Service Bulletin No. 116

Subject: Battery Box Lid

To: All Owners of Piper Model PA-20 Serial Numbers 20-553 thru 20-600 incl., 20-602 thru 20-623 incl., 20-627 thru 20-631 incl., 20-633 thru 20-641 incl., 20-643 thru 20-649 incl., 20-651, 20-654, 20-656, 20-660 and 20-662; also, Model PA-22 Serial Numbers 22-1 thru 22-33 incl., 22-35 thru 22-37 incl., 22-43, 22-51, 22-53 and 22-54.

FOUR ANGLES SPOTWELDED TO INSIDE OF LID

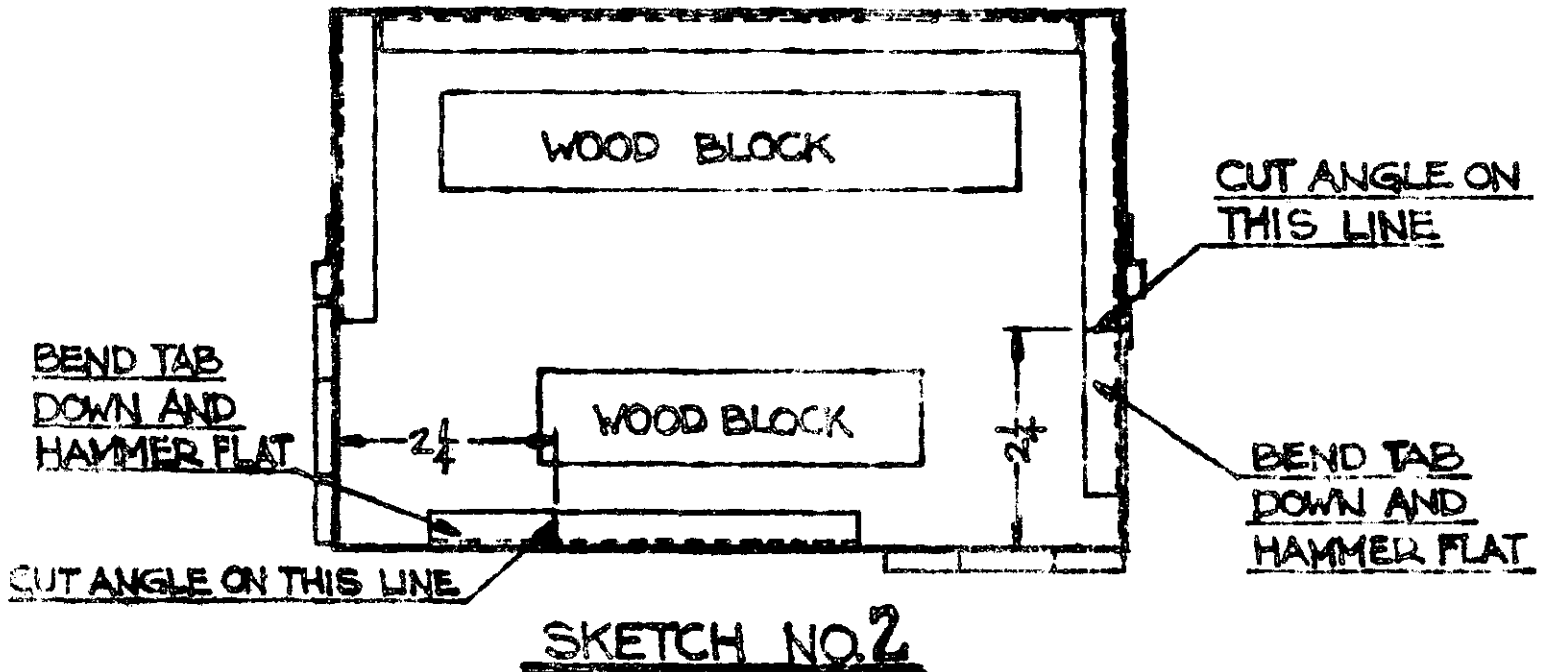
Lids of the type construction shown in Sketch No. 2 must be reworked as indicated.
